CITY PLAN COMMISSION**THURSDAY, NOVEMBER 3, 2022****FILE NUMBER:** S223-001**SENIOR PLANNER:** Mohammad H. Bordbar**LOCATION:** Duncanville Road, north of West Ledbetter Drive**DATE FILED:** October 6, 2022**ZONING:** IR**CITY COUNCIL DISTRICT:** 3 **SIZE OF REQUEST:** 17.644 -acres **MAPSCO:** 62C**APPLICANT/OWNER:** Cowboy and Sons

REQUEST: An application to create one 17.644-acre lot from a tract of land in City Block 8018 on property located on Duncanville Road, north of West Ledbetter Drive.

STAFF RECOMMENDATION: The request complies with the requirements of the IR Industrial Research District; therefore, staff recommends approval of the request subject to compliance with the following conditions:

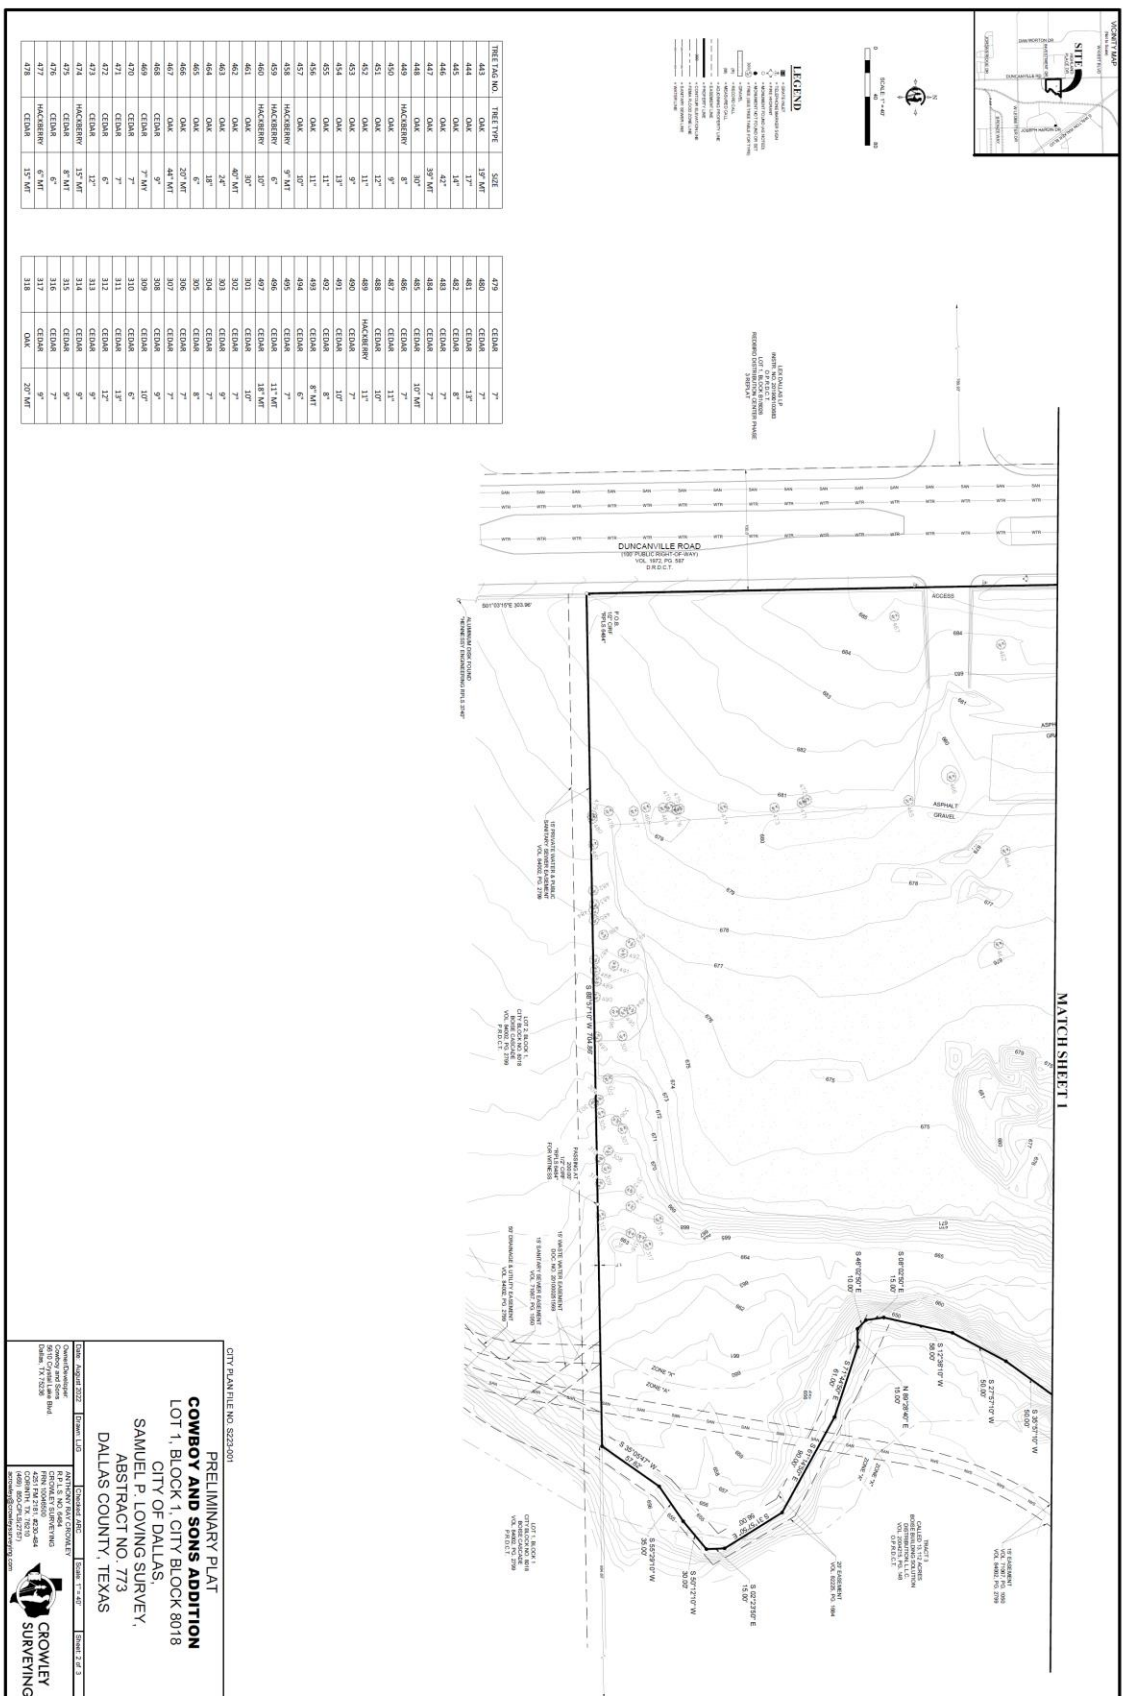
15. On the final plat, dedicate 50 feet of right-of-way (via fee simple) from the established center line of Duncanville Road. Section 51A 8.602(c)

16. On the final plat, determine the 100-year water surface elevation across this addition.
17. On the final plat, dedicate floodway easement, floodway management area or floodway easement (within common area), with the appropriate easement statement included on the face of the Plat. 51A 8.611(d); DWU Floodplain Management; Drainage Design Manual Addendum V

18. On the final plat, include additional paragraph in Owner's Certificate (pertaining to the floodplain). 51A 8.611(d); DWU Floodplain Management; Drainage Design Manual Addendum V

19. On the final plat, specify minimum fill and minimum finished floor elevations. *Section 51A-8.611(d), Trinity Watershed Management.*
20. On the final plat, show the natural channel set back from the crest of the natural channel. *Section 51A-8.611(d), Trinity Watershed Management.*

21. Prior to submission of the final plat, set floodway monument markers and provide documentation that the monuments have been set. *Section 51A-8.617(d)(1), (2), (3), and (4)*

30. On the final plat, identify the property as Lot 1 in City Block 10/8018. Ordinance 1A, Page 131 pages 131-148, Section 2 (passed August 13, 1872).
